Access Compliance Report

Public Rights-of-Way

(Curb Ramps)

Intersection ID: 49131	Main Street: EWERT_CUT_LN	Cross Street: WILTSHIRE_RIDGE_RD	Location: S
ADA ID: 68B63FA76717	Ramp Type: Perp	Initial Pass/Fail: Pass	Overall Compliance: No
Severity Score: 5.25			
Codes/Mitigation Info/Possible Solution		Field Measurements/Component Compliance

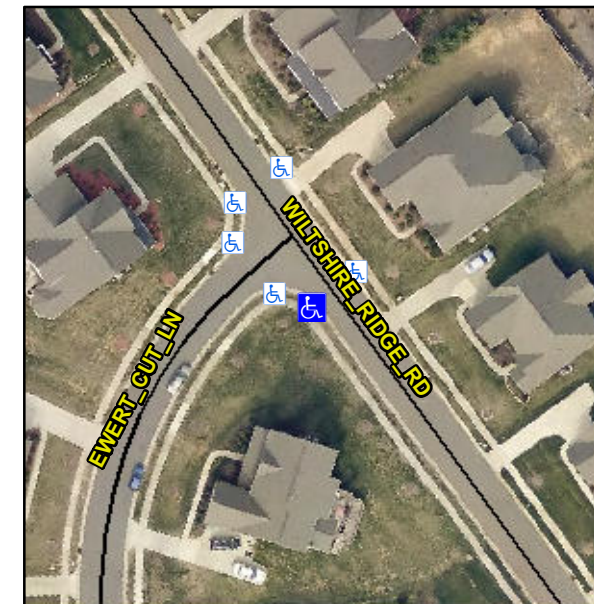
Not Found, R304.5.3, R304.2.2-Perp, R304.3.2-Para, R304.2.3, R305.2

Compliance	Description	Data	Compliance	Description	Data
N/A	Ramp Length (in)	48.0	Yes	Ramp Slope (%)	7.4
Yes	Ramp Width (in)	48.0	No	Ramp XSlope (%)	4.8
N/A	Flare Type LT	Sloped	N/A	Flare Type RT	N/A
N/A	Flare Slope LT (%)	3.1	No	Flare Slope RT (%)	12.3
N/A	Flare Traversable LT?	Yes	N/A	Flare Traversable RT?	Yes
Yes	Landing Length (in)	48.0	Yes	DWS Provided?	Yes
Yes	Landing Width (in)	48.0	Yes	DWS Contrast?	Yes
No	Landing Slope (%)	2.5	Yes	DWS Length (in)	24.5
Yes	Landing X Slope (%)	3.8	Yes	DWS Full Width?	Yes
N/A	Landing Curb? (Y/N)	No	No	DWS Offset (in)	4.0
N/A	Shared Landing?	No			
Yes	Gutter Ponding?	No	Yes	Gutter Slope (%)	1.8
Yes	Gutter Lip Ht (in)	0.0	Yes	Gutter X Slope (%)	4.1
N/A	Painted X Walk1?	No	N/A	Painted X Walk2?	N/A
	X Walk 1 Direction	To NE		X Walk 2 Direction	N/A
N/A	X Walk 1 Width (in)	N/A	N/A	X Walk 2 Width (in)	N/A
	X Walk 1 Slope (%)	1.4		X Walk 2 Slope (%)	N/A
	X Walk 1 X Slope (%)	4.5		X Walk 2 X Slope (%)	N/A

Remove & Replace Entire Ramp.
